Contract #: 04-0120F4Cty: SF/ALA Rte: 80 PM: 13.2/13.9File #: 69.25B**QUALITY ASSURANCE -- NON-CONFORMANCE REPORT****Location:** Changxing Island, Shanghai, P.R. China**Report No:** NCR-000381**Prime Contractor:** American Bridge/Fluor Enterprises, a JV**Date:** 06-Aug-2009**Submitting Contractor:** Zhenhua Port Machinery Company, Ltd (ZPMC), Changxing Island**NCR #:** ZPMC-0355**Type of problem:****Welding****Concrete****Other****Welding****Curing****Procedural****Bridge No:** 34-0006**Joint fit-up****Coating****Other****Component:** OBG Cantilever Box Bracket**Procedural****Procedural****Description:****Reference Description:** Missed MT Transverse Indication by QC on Bikepath Cantilever Box Bracket**Description of Non-Conformance:**

Subject: NCR No. ZPMC-0355

Reference Description: Missed MT Transverse Indication by QC on Bikepath Cantilever Box Bracket

关键焊缝返修报告 Critical Welding Repair Report (CWR)			版本 Rev. No.:
					0
项目名称 Project Name:	美国海湾大桥 SFOBB	部件图号 Drawing No.:	BK1	报告编号 Report No.:	B-CWR654
合同号 Contract No.:	04-0120F4	部件名称 Item Name:	CANTILEVER BOX BRACKET	NDT 报告编号 NDT Report No.:	B787-MT-12785
项目编号 Project No.:	ZP06-787

We found one transverse crack on the BK001-026-035

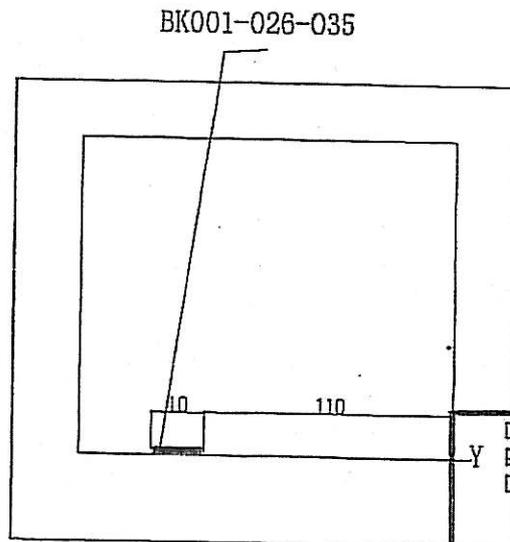
1. 火焰加热时, 水汽没有完全的去掉或者这个区域预热不够;
1. Moisture wasn't completely removed during drying operation (preheating) or the area wasn't preheated sufficiently.

1. QC and a Lead CWI shall be present, direct and supervise all grinding and welding operations during this repair to ensure the repair is per the disposition requirements

2. QC and a Lead CWI shall have an approved copy of the CWR in hand prior to the repair.
3. Remove paint ≥ 25 mm in all direction of HAZ prior to MT.
4. Remove cracks by grinding, repair area shall extend a minimum of 50mm beyond each end of single crack repairs, and 50mm beyond the outermost cracks for multiple crack repairs.

5. Perform hardness testing across the transverse crack. Notify the Engineer prior to performing hardness testing, and submit hardness test results prior to performing repair work.

6. Prepare excavation in accordance with an approved repair WPS prior to welding.
7. Before this repair, Verify with VT and MT repair areas are defects free;

8. Preheat and weld according to the approved repair WPS.
9. Grind the repaired area flush with base metal or the adjacent weld;
10. Perform NDT in accordance with approved Contract Drawings, and perform additional NDT in accordance with Section 10-1.59 of the Special Provisions 'Steel Structures', subsection 'Inspection & Testing' Note 3.

NTI BASE METAL TO ENSURE CRACK DIDN'T PROPAGATE INTO BM. IF CRACK IS DISCOVERED IN BM SEPERATE CUR REQ'IS.
